# Product Change Notification

**Change Notification #:** 117126 - 01

**Change Title:** Intel® Server System R1304WFTYS ,  
PCN 117126-01, Product Design, Label,  
Update BIOS/BMC/ME/FRUSDR, Firmware,  
1100W Power Supply Add URL to BIS mark,  
3.5" Tool-Less Carrier Design Improvement  
for 2.5" Drive Support  
**Reason for Revision: Correct Post-Change TA**

**Date of Publication:** September 09, 2019

Image 1. Power supply label before change

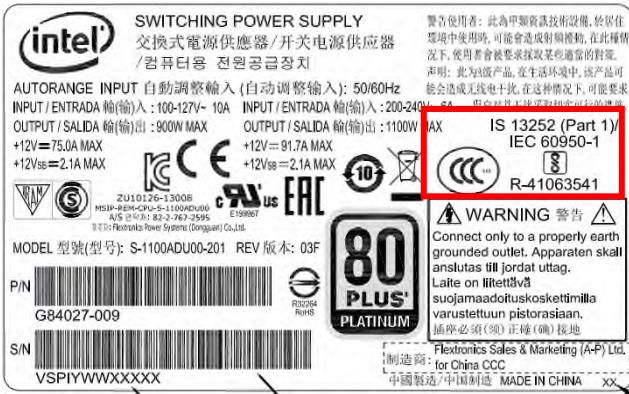
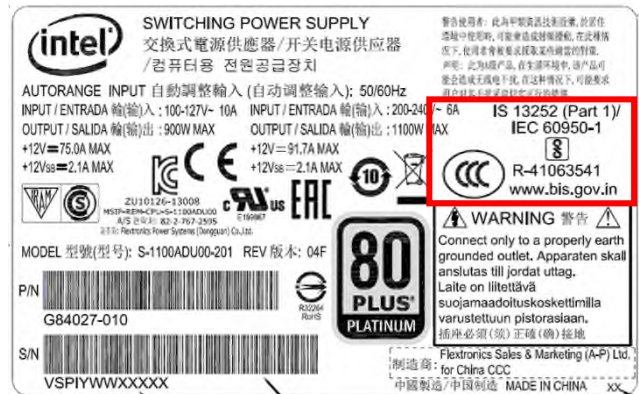
- Update the label of the 1100W power supply included in the Intel® Server System R1304WFTYS. The new label includes a URL of the BIS mark and remove “S&E” inside the CCC logo.

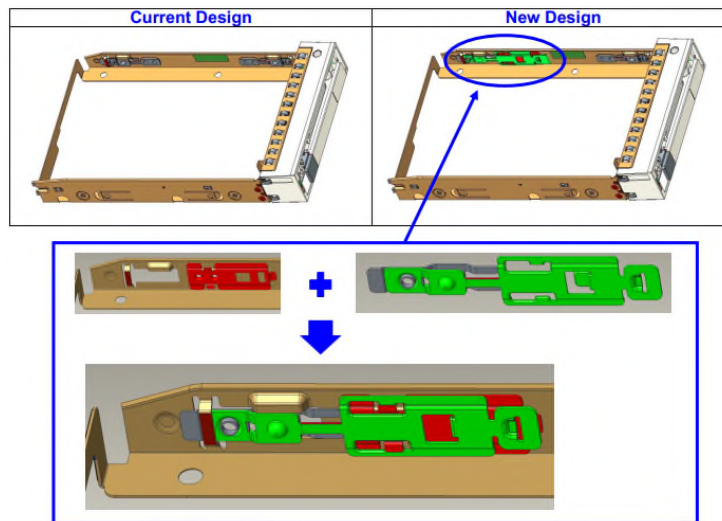
- Improvement for the 3.5” tool-less drive carrier when used for 2.5” drive support, from a non-removable to a new removable rear spring (see image in green) and new spring holder (see image in red) attached to the tool-less drive carrier.

Removing the new rear spring of 3.5” tool-less carrier when installing 2.5” SSD drive, installing the rear spring to support 3.5” HDD.
